**AMENDMENTS TO THE DRAWINGS**

**REMARKS**

Fig:2

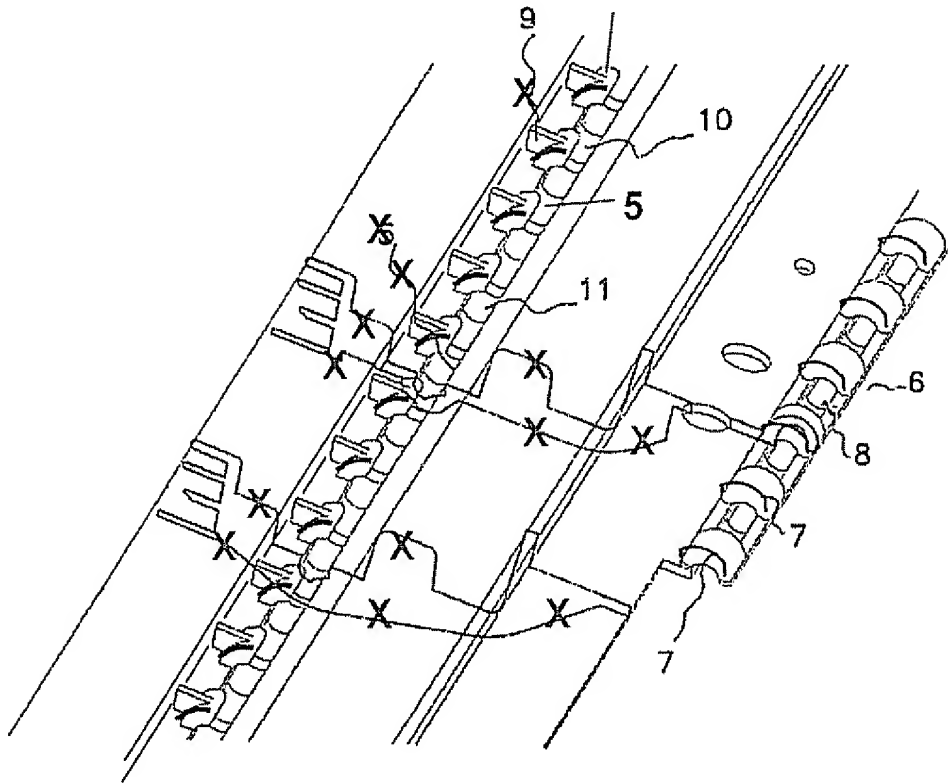
The attached sheets of drawings include changes to Figs. 2 and 4. These sheets, which include Figs. 1-4, replace the original sheets including Figs. 1-4. In Figs. 2 and 4, projection images have been deleted as shown in the attached annotated sheets, wherein deleted lines are marked with an "X." As only deletions have been made to the figures, no new matter has been added with the proposed amendments. Entry of the replacement sheets of drawings into the application is respectfully requested.
